# PONTIAC

## Service Craftsman News

No. 9 S-266

# 1955 NEW MODEL INFORMATION

Fig. 2 Early and Revised Type Intake Manifolds

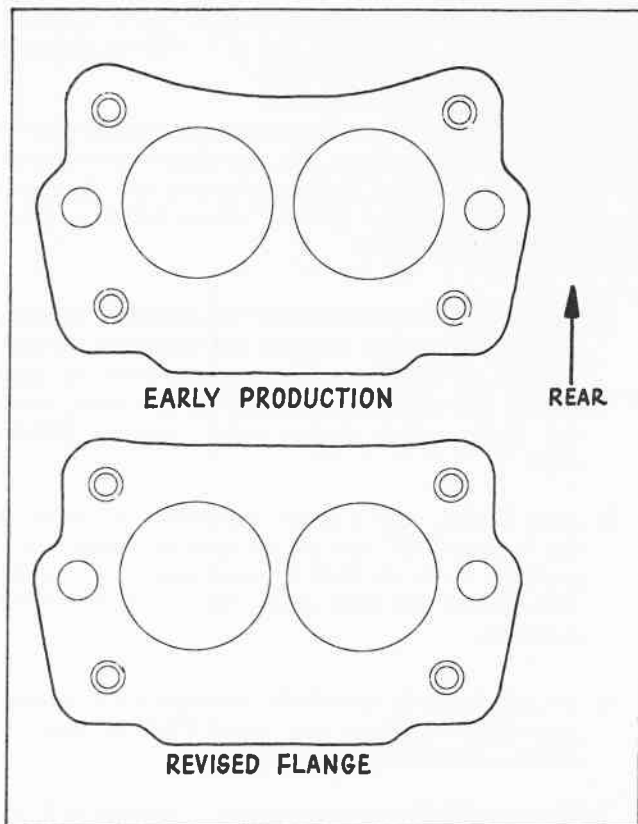
Approximately 1,000 engines have been built with an intake manifold which will accommodate the Carter Carburetor only. After these first 1,000 engines, the manifold casting is changed so as to accommodate either the Rochester or Carter carburetors. The early manifold can be identified by a curved section at the rear of the carburetor mounting flange (Fig. 2) while the revised manifolds are nearly straight across the rear of the carburetor mounting flange.

If a Rochester Carburetor is inadvertently installed on one of the early intake manifolds, there is a possibility of a high vacuum leak at the windshield wiper vacuum passage in the carburetor flange due to insufficient sealing area.

Fig. 3 Checking Fast Idle Adjustment

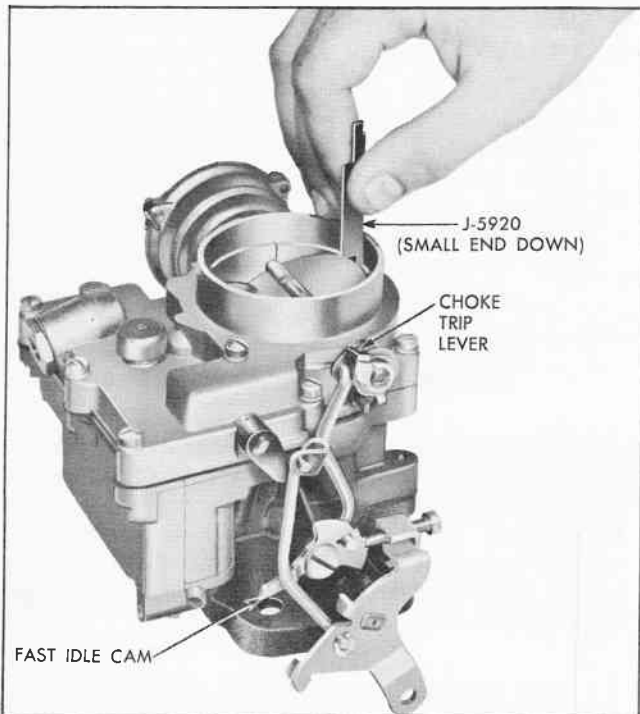
1. On page 6B-26, step number 1 under Fast Idle Cam Index Adjustment, use the small end of tool J-5920 as shown in Fig. 3 instead of a #55 drill.

Fig. 4 Checking Unloader Adjustment

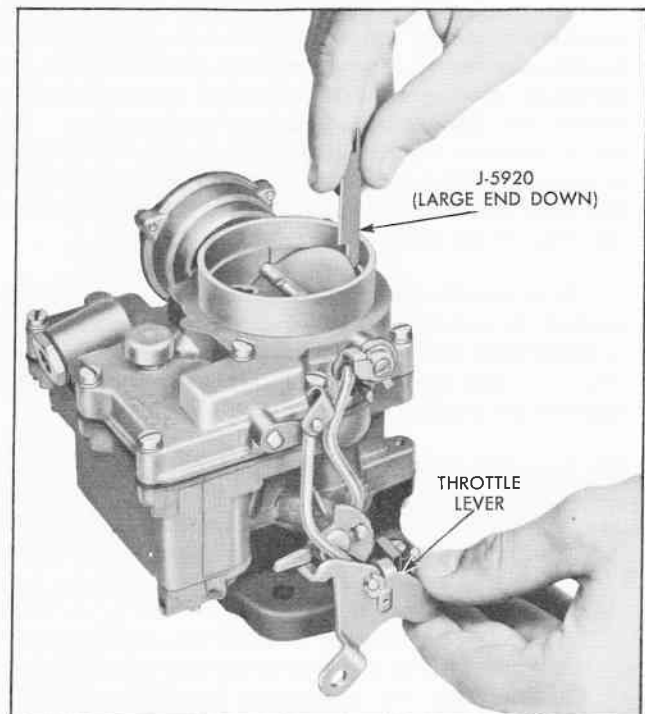
2. On page 6B-27, step number 2 under Unloader Adjustment, use large end of J-5920 as shown in Fig. 4 instead of a #20 drill.
3. On page 6B-28 the disassembly procedure cannot be followed as given. The two choke valve screws are now installed from the bottom and it is necessary to remove the bowl cover before removing the choke valve.

Fig. 5 Correct Assembly of Tool J-5712

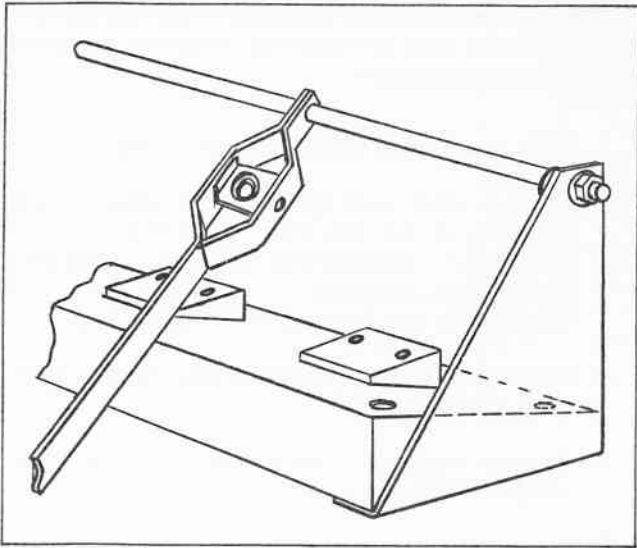
Tool J-5712 is shipped disassembled and must be assembled in the dealership. Fig.5 shows the proper assembly of the base and end pieces. Note that the thinnest edge of the base goes to the vertical edge of the end pieces. Improper assembly will result in incorrect operation of the tool.
